P P544476
 A _____

Tax ID # 03-593806
ON-SITE SEWAGE DISPOSAL SYSTEM
HOWARD COUNTY HEALTH DEPARTMENT
BUREAU OF ENVIRONMENTAL HEALTH

ADDRESS: 12115 Old Frederick Road PROPERTY OWNER: Ruth Fisher and Charles Cole Jr.

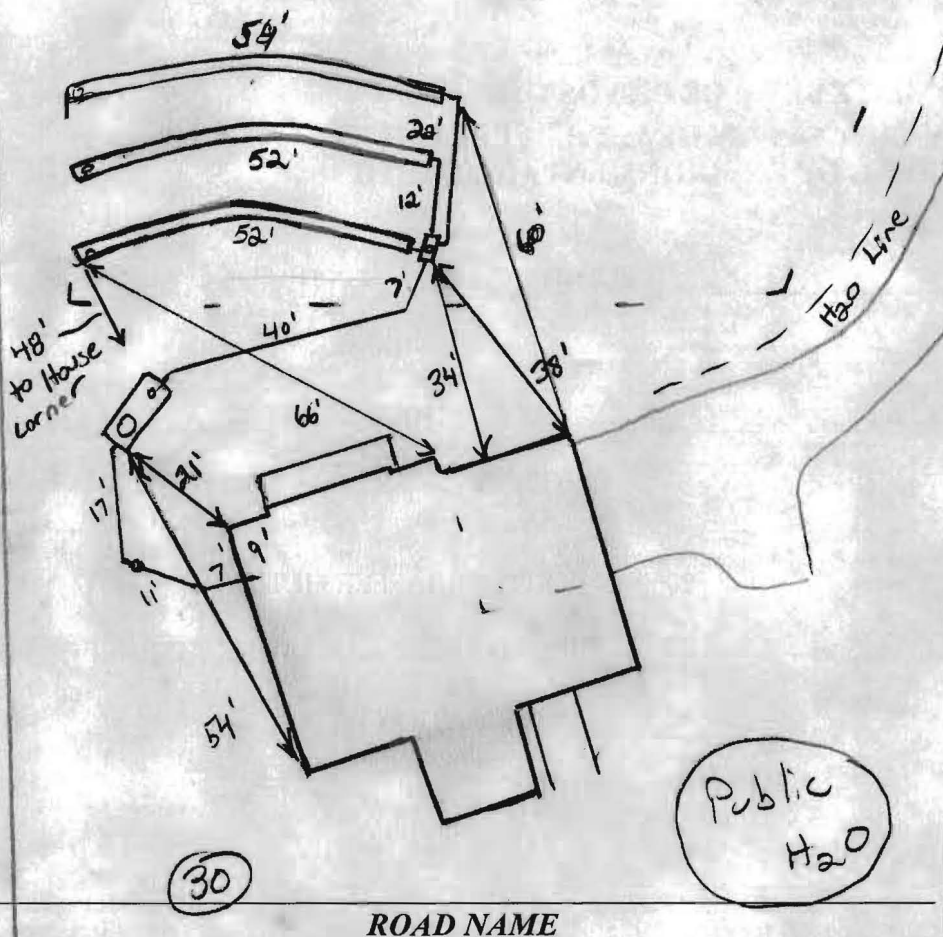
LINEAR FEET OF TRENCH REQUIRED: 155' Can't go shallower than 4' per contract screw-up

1/22/13 Upon arriving on-site, contractor was digging tank hole. No septic area stake found. Contractor was unaware of my procedures for the Co onsite septic installation. Tank hole was only 10' from foundation. Contractor did not want to shoot any elevations. Move tank hole location to meet 20' setback. Get surveyed septic area stakes and call in for trench layout. Also tanks hole very deep. Told contractor did not want to argue. Need to make 4' inlet invert to trenches via gravity. Must work or tank will have to be re-set (K) 1/24/13 S.T. set 20' from house. Shot contour. Set Dbox middle of SRA. install 2x52' as per permit running towards lot 41. Call for imp. Stone onsite, only 66 ton per contractor. Told him system designed for 78 ton, will perform imp. Must see stone trucks (K) 1/25/13

INSTALLATION: Top 2 trenches complete. Digging bottom trench. Need house connection, leveler in Dbox w/ water to level out, and distribution network (K) Dbox leveled, House connection made OK to cover all work (K)
